NUREG/CR-3300
SAND83-1118
Vol. 1

Review and Evaluation of the Zion Probabilistic Safety Study

Plant Analysis

Figure 2.7.1-1. Seismicity Based on Nuttli (Reference 2-24)

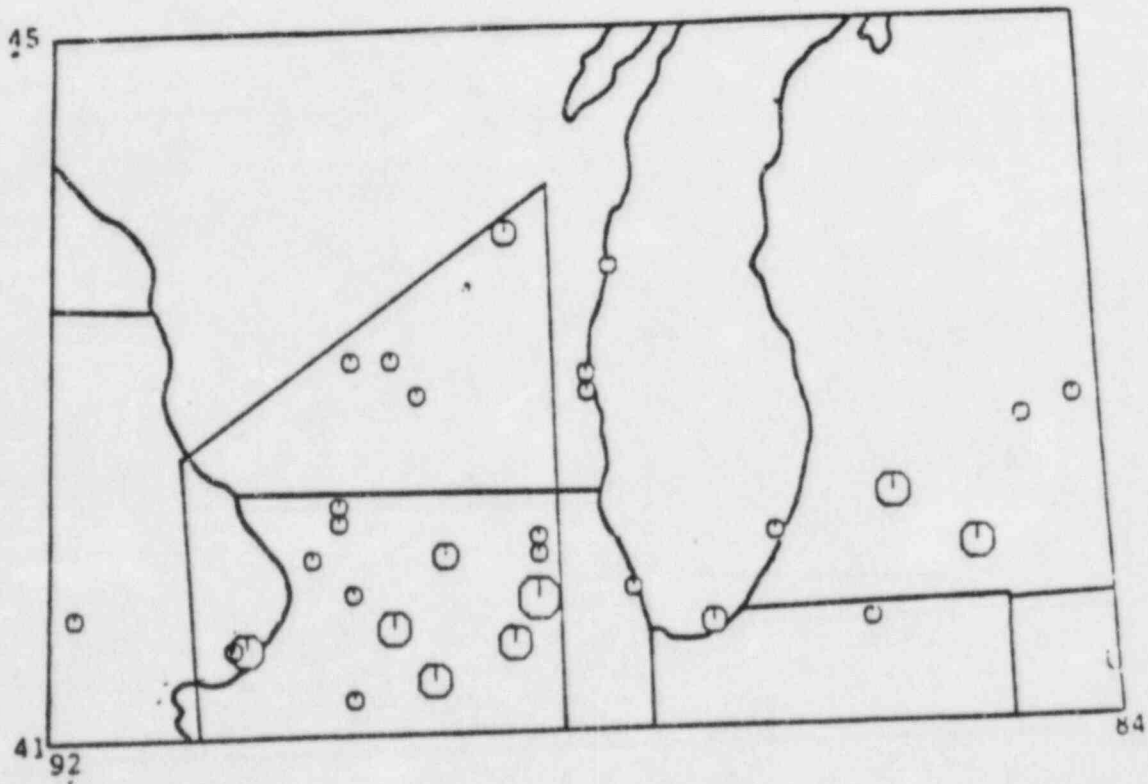
Figure 2.7.1-1 is a plot of the seismicity listed by Nuttli (1979) for the area bounded by the latitudes of 41° and 45°N and the longitudes of 84° and 92°W. The earthquakes in the figure are plotted to scale in accordance to their epicentral intensities. Two earthquakes not shown in the figure, but which appear in Nuttli's (Reference 2-24) catalogue, are the events of February 9, 1899, and May 19, 1906. The first event is listed in Barstow, et al., (Reference 2-19) as not being an earthquake, while the second event was determined to be 800 kegs of blasting powder exploding at Pleasant Prairie, Wisconsin.

Another difference between the seismicity plotted in Figure 2.7.1-1 and that listed by Nuttli is the epicentral location of the May 26, 1909, event. After reviewing the distribution of the earthquake effects, it is felt that the epicenter near Aurora, Illinois, as suggested by Docekal (Reference 2-21) is more appropriate than 42.5°N/89.0°W used by Nuttli (1979) and Coffman and von Hake (Reference 2-20). The results of the review of this event are discussed below.

Illustrated along with the seismicity in Figure 2.7.1-1 is the outline of the proposed Wisconsin Arch seismogenic zone. The proposed zone does a poor job of accounting for the known seismicity in the area and does not seem to be justified.

Figure 2.7.1-2. Wisconsin Arch-Michigan Basin

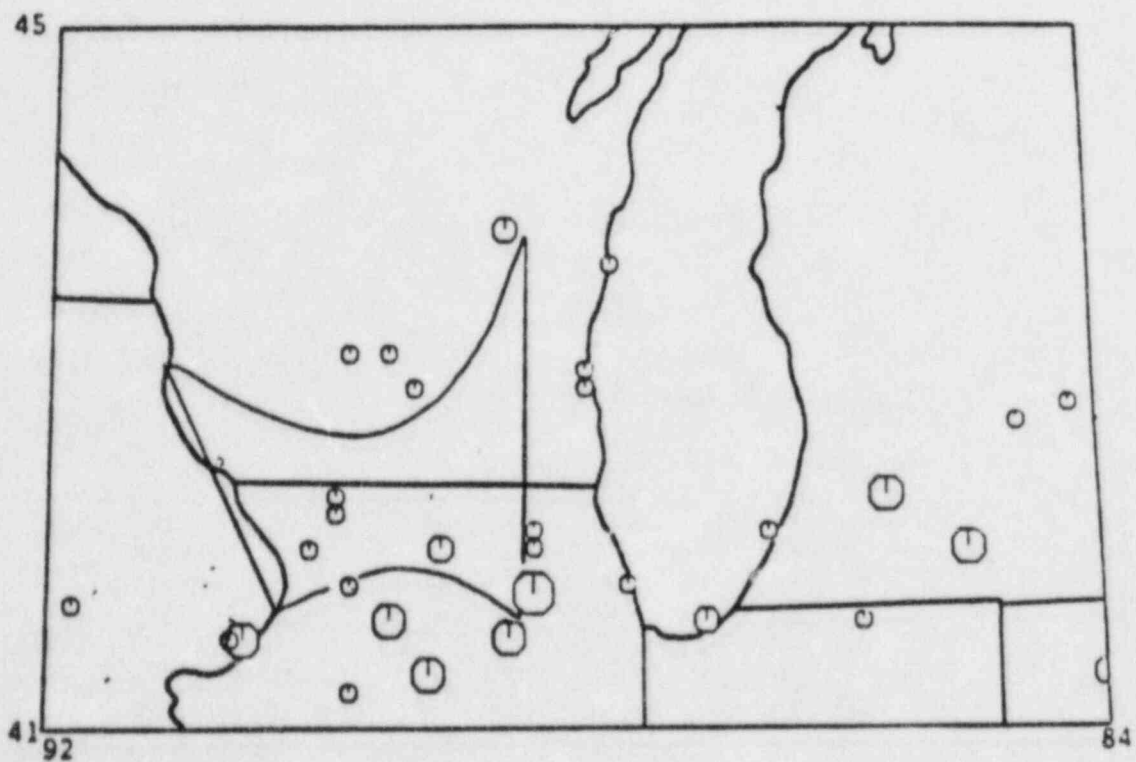
Figure 2.7.1-2 illustrates the same seismicity shown in Figure 2.7.1-1, but with an outline of the proposed Wisconsin Arch-Michigan Basin seismogenic zone. We have two problems with this zone. Firstly, as with the Wisconsin Arch zone, the proposed Wisconsin Arch-Michigan Basin zone does not correlate well with the known seismicity. And secondly, based on the gravity data of the region about

northeastern Illinois and southern Michigan, the proposed seismogenic zone cuts across a major basement structure and suggests that such a zone is unlikely.

Figure 2.7.1-3. Proposed Seismogenic Zones

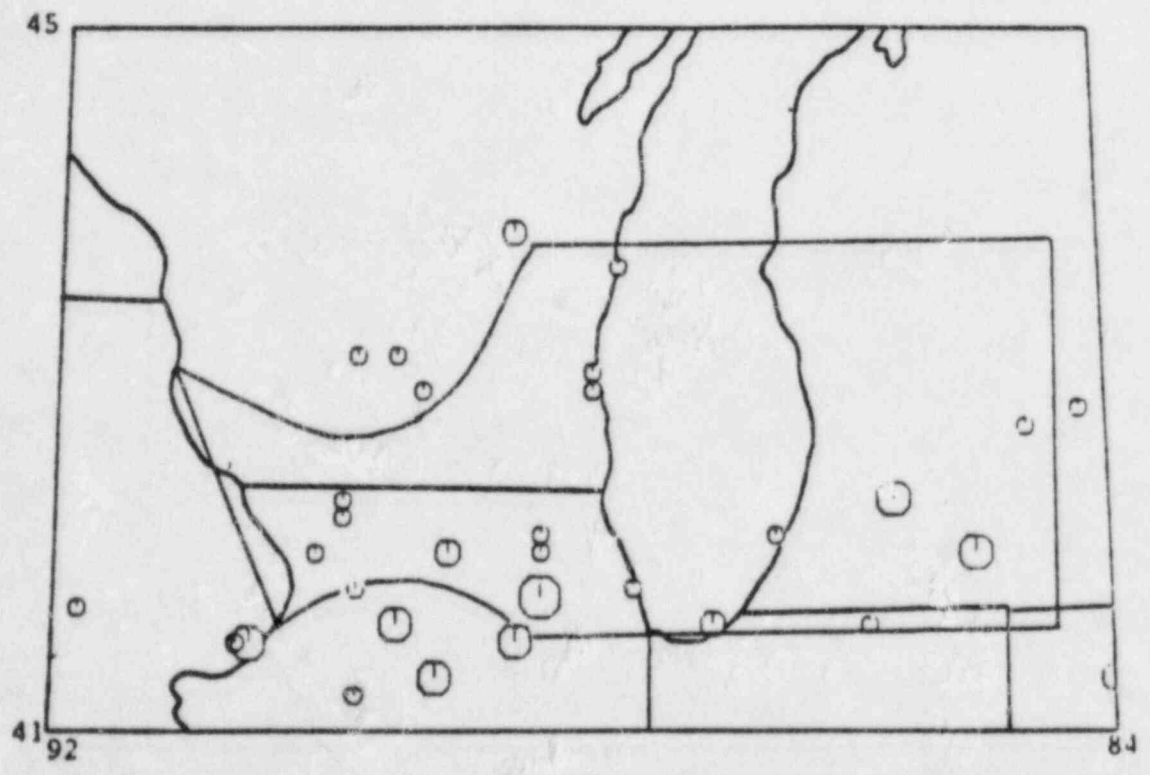
As an alternative to the proposed Wisconsin Arch and Wisconsin Arch-Michigan Basin seismogenic zones, it is suggested that a zone more on the order of the one outlined in Figure 2.7.1-3 be used. This zone is similar to the Northern Illinois zone proposed by Nuttli and Herrmann (Reference 2-23), but unlike their zone, the outlined zone in the figure has been extended northwards to include the seismic activity that seems to be spatially associated with the southern border of the Wisconsin Dome. In addition, the outlined zone correlates somewhat with the proposed Wisconsin Arch zone except that by considering a larger area--particularly in the southerly direction--all of the significant seismic activity has been indicated.

Figure 2.7.1-5

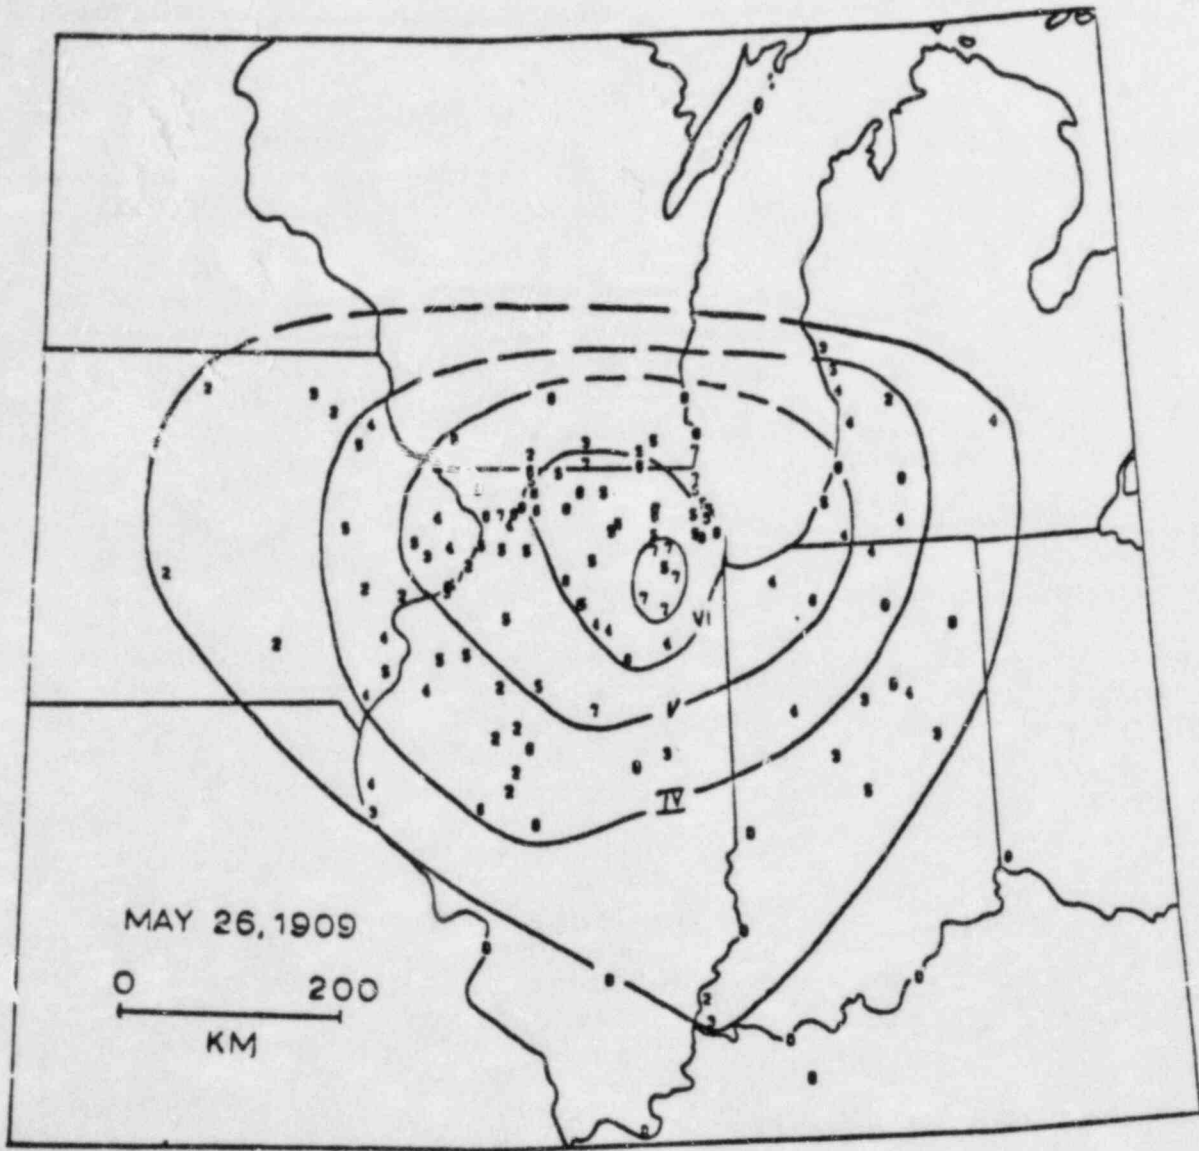
Figure 2.7.1-5 illustrates the distribution intensity data for the May 26, 1909, event based on a review of the newspaper articles for this event. Superimposed on the figure is the interpretation of where the various isoseisms

should be drawn. The isoseisms, along the northern portion of the map, are dashed to indicate the uncertainty resulting from the lack of information. Note that the greatest level of concentration occurred in and about the Aurora, Illinois area and it is for this reason that Docekal's (Reference 2-21) epicentral coordinates were chosen rather than those of Nuttli (Reference 2-24) and Coffman and von Hake (Reference 2-20).

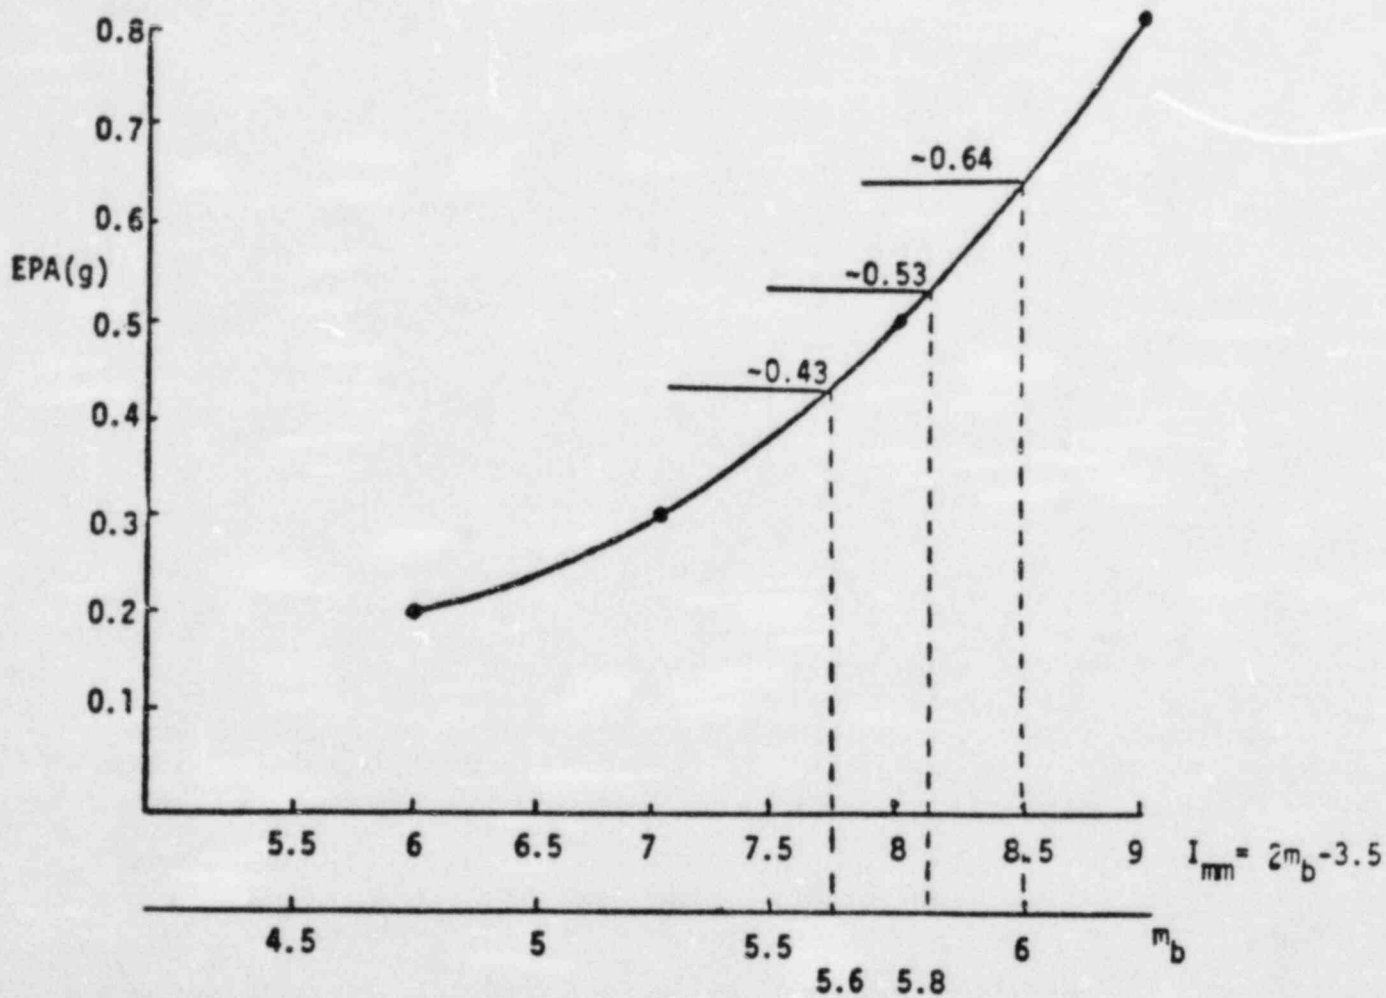
a. We cannot follow the argument that imposes limits to the EPA based on limits on I_{mm} . That argument is especially tenuous if EPA is defined as $EPA = A_{3F}$ (Equation 4 of Section 7.9.3). In this case, the statement at the top of Page 12 in Section 7.9.1 does not hold. We also find it objectionable to use damage to masonry construction in order to obtain limits on EPA for nonmasonry structures.

b. If an upper bound to EPA exists, such bound should be included through truncation of the attenuation error distribution, not through correction of the final hazard curves.

c. There is no evidence in the report that the curves of Figure II.7.1 have actually been calculated.

d. We have tried to reconstruct the method used to obtain the upper bounds on EPA in Figure II.7.1. It seems that upper bound intensity values have been found from upper bound magnitudes using the relationship $I_{mm} = 2m_b - 3.5$ and that the associated upper bounds EPA have been calculated by interpolation of the values on Page 6 of Section 7.9.3. (See Figure 2.7.1-6.) However, the above relationship between I_{mm} and m_b was obtained by fitting dispersed data and does not apply to upper bounds.
